RENESAS TECHNICAL UPDATE

Product Category	MPU/MCU		Document No.	TN-RA*-A0149A/E	Rev.	1.00
Title	Note about the interruption during the transition to low power modes		Information Category	Technical Notification		
Applicable Product	RA0E1, RA0E2, RA2L1, RA2L2, RA2E1, RA2E2, RA2E3, RA2A1, RA2A2 Group	Lot No.	Reference Document	Refer table at the end of this document		
		All

Corrections are made to the figures and tables in the user's manual hardware as shown in 1 and 2 below.

1) Figure 9.1 of RA0E1 and RA0E2 groups

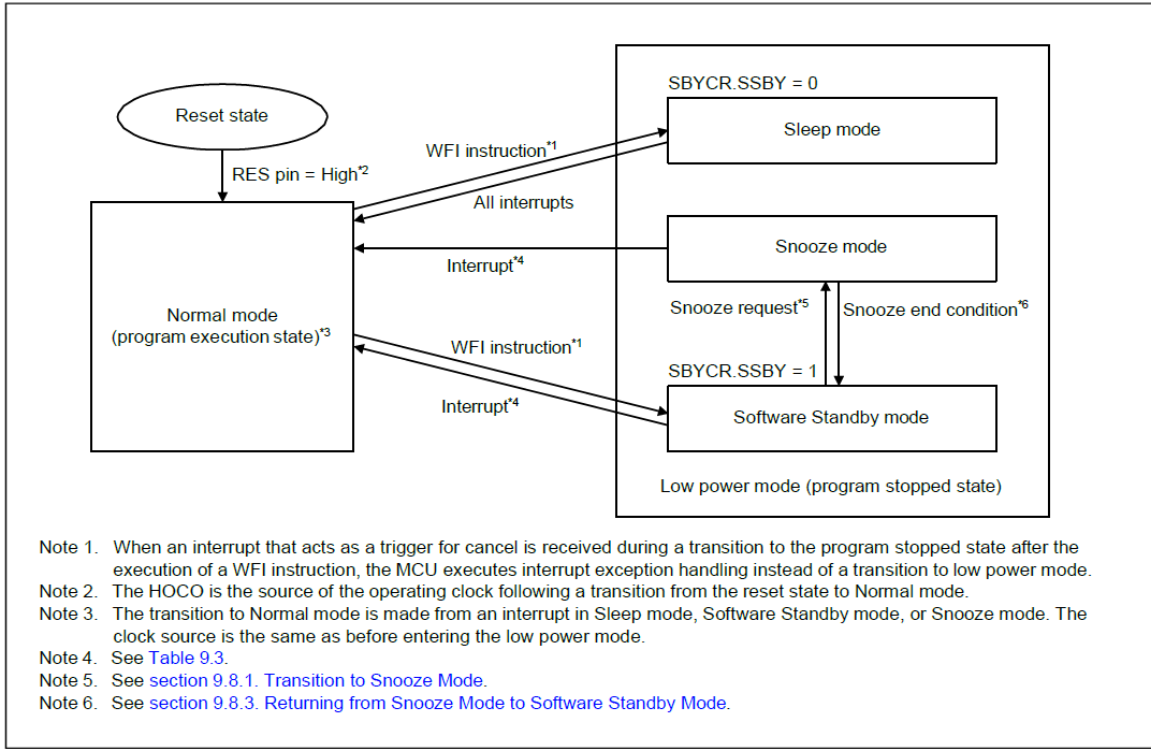
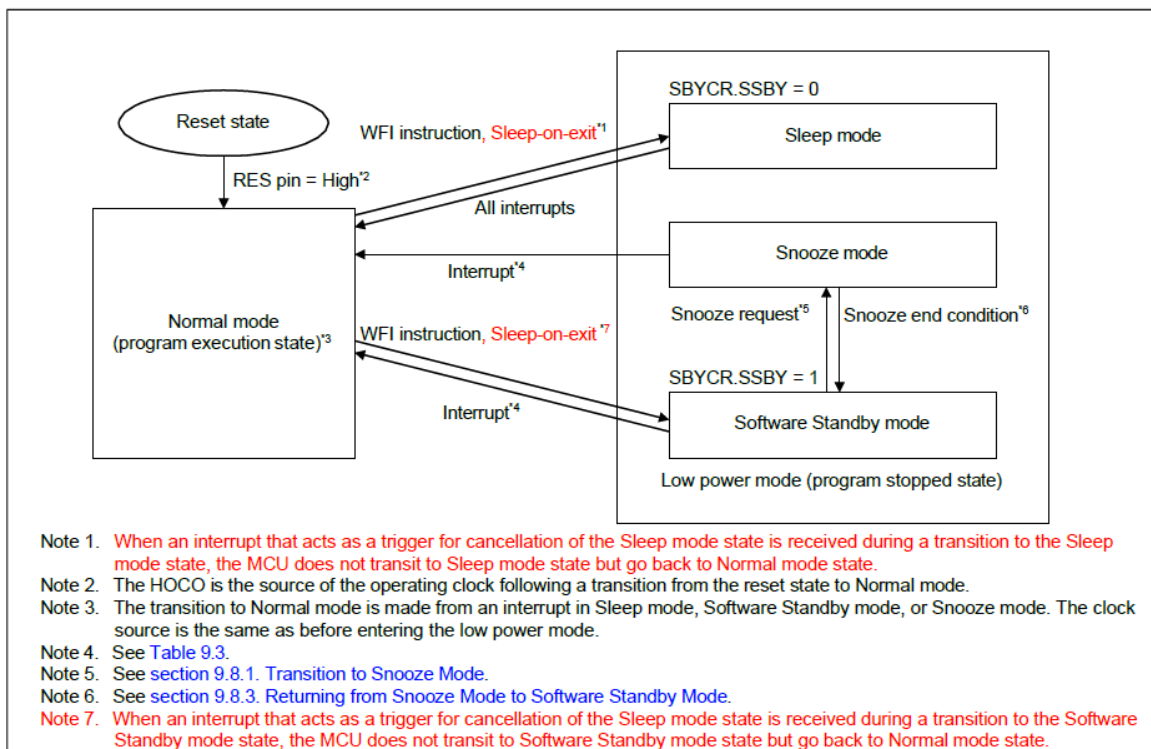
Before correction

After correction

2) Figure 10.1 of RA2L1, RA2L2, RA2E1, RA2E2 and RA2E3 groups

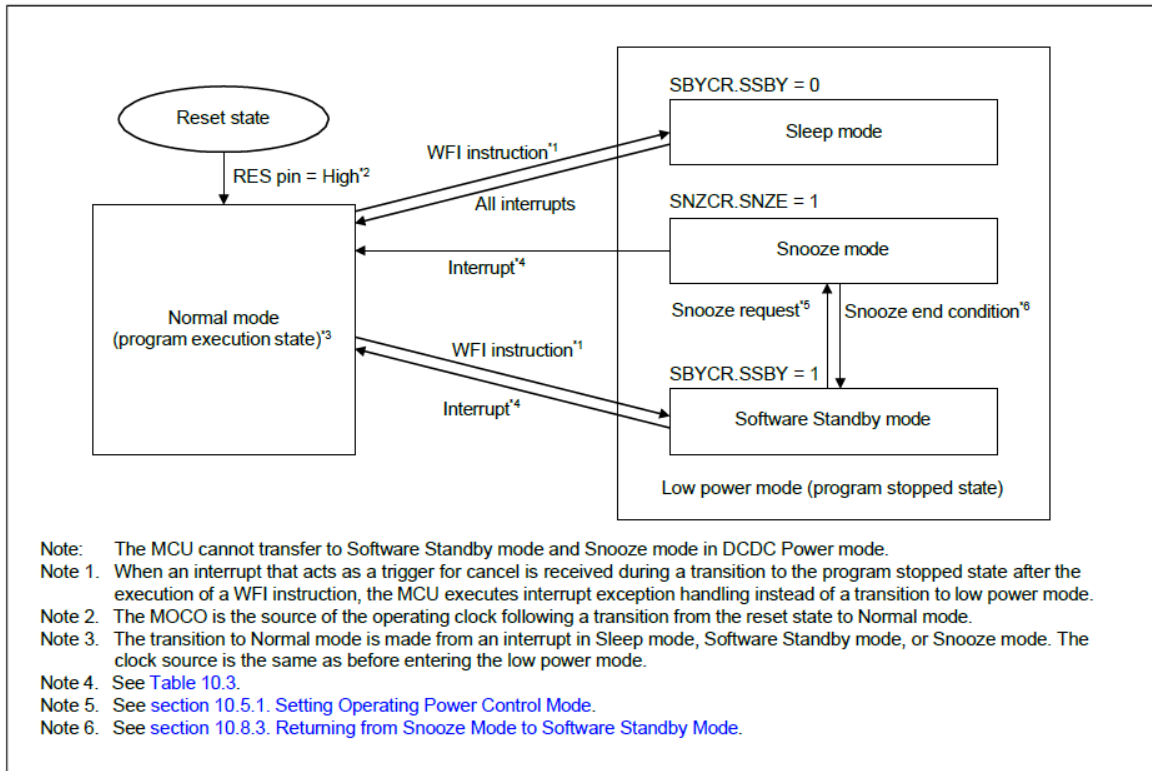
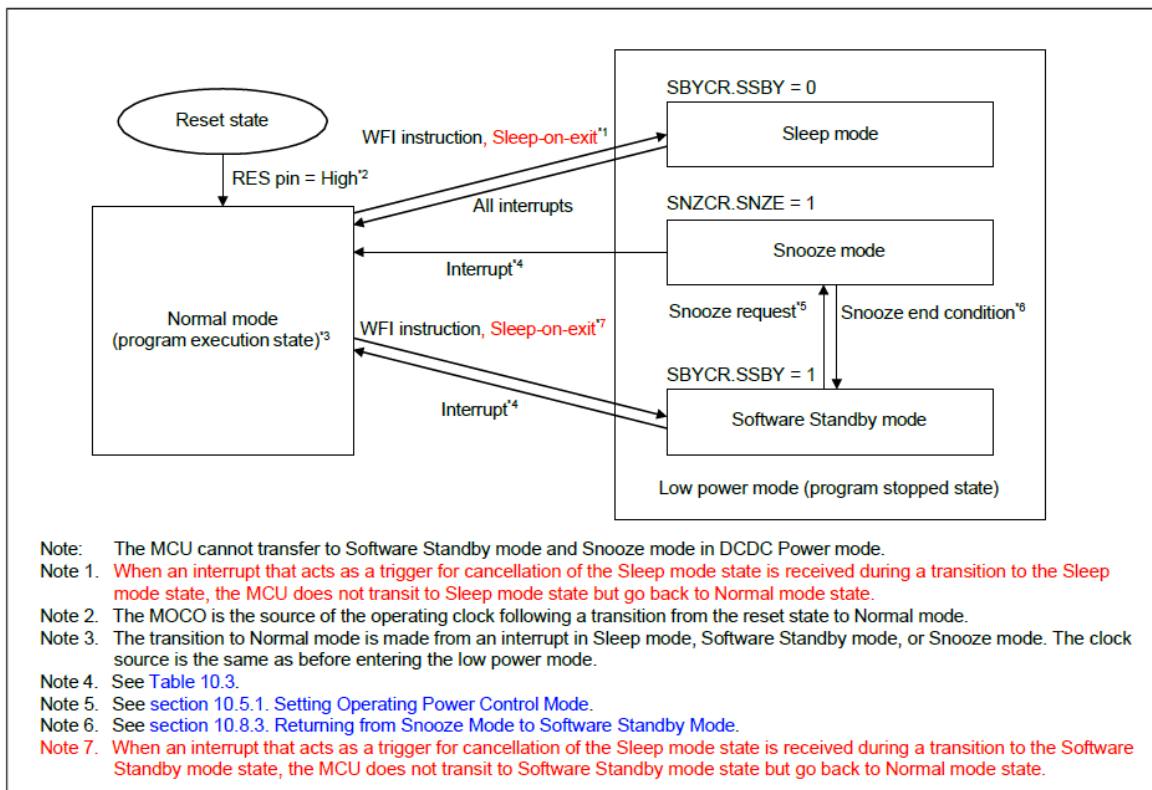
Before correction

After correction

3) Figure 11.1 of RA2A1 group

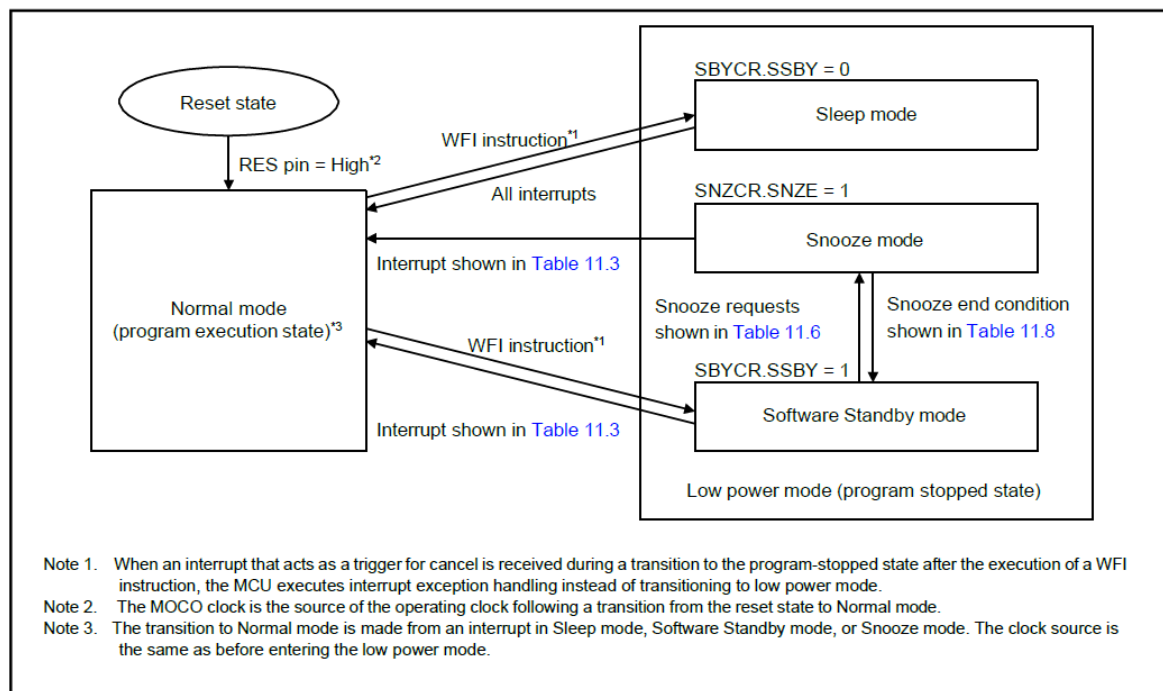
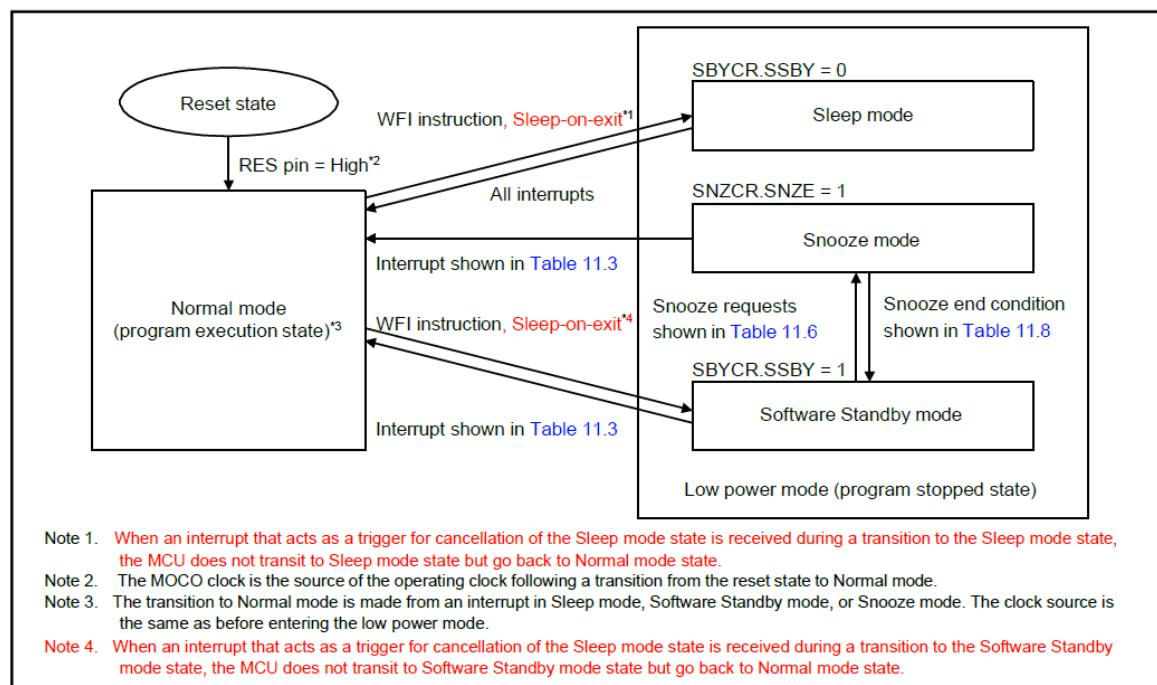
Before correction

After correction

4) Figure 11.1 of RA2A2 group

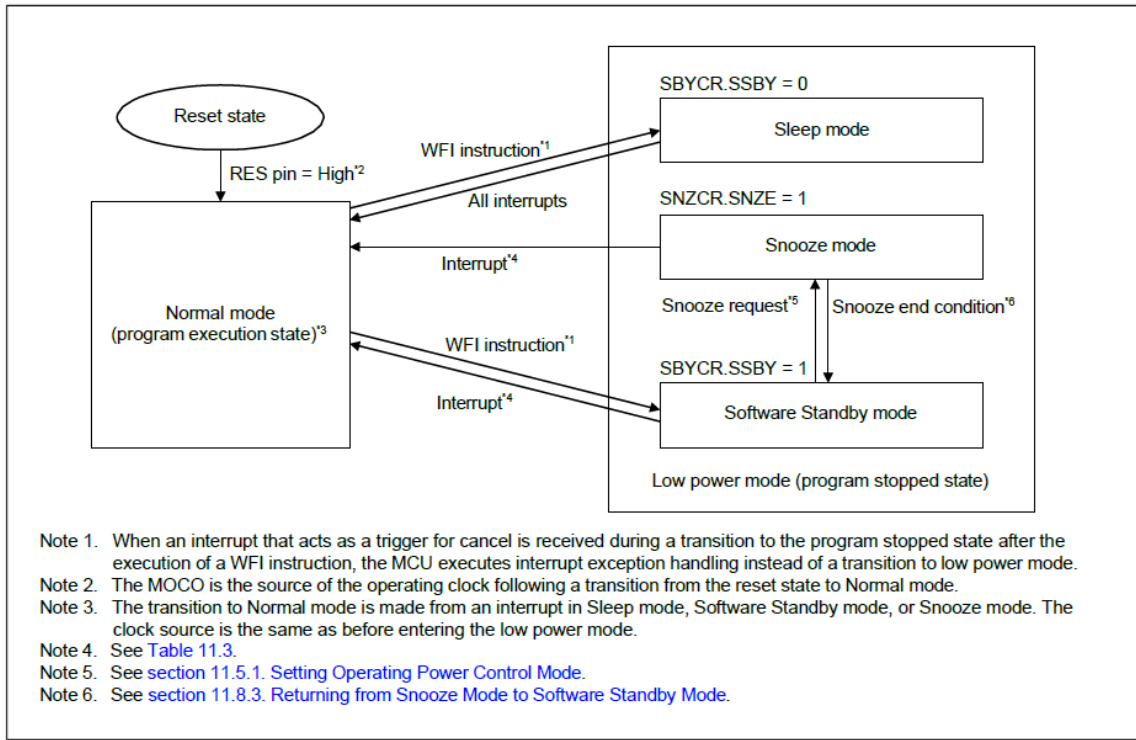
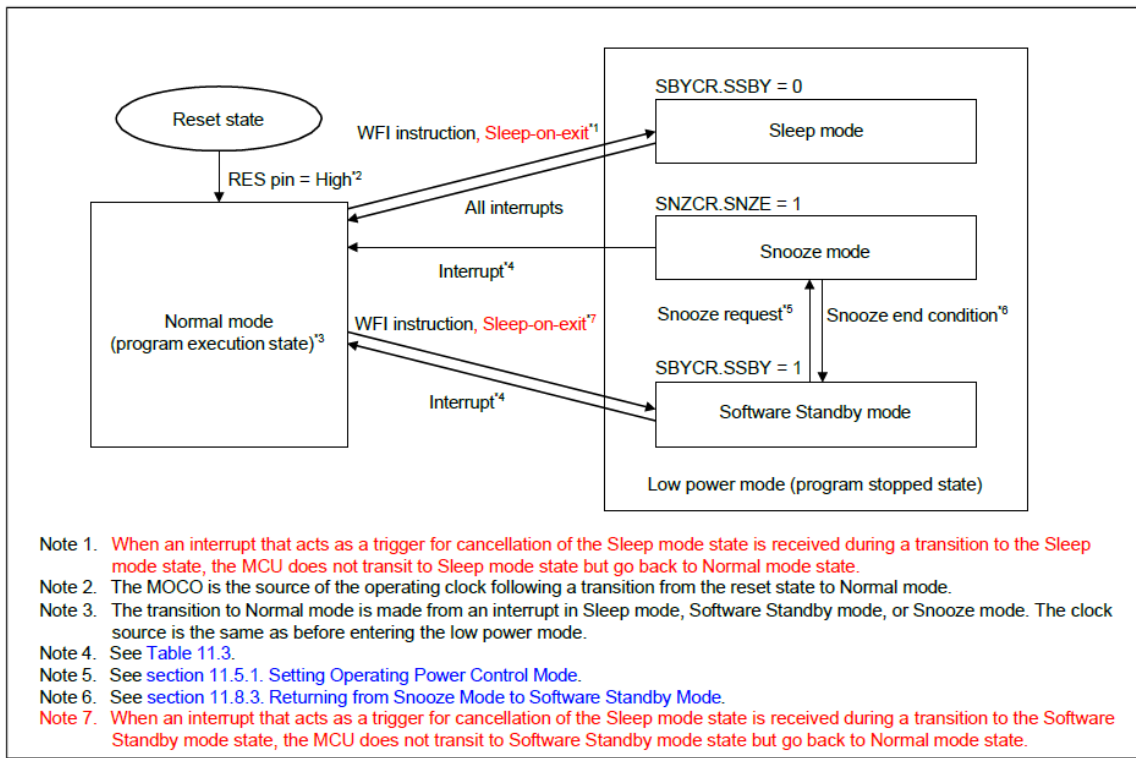
Before correction

After correction
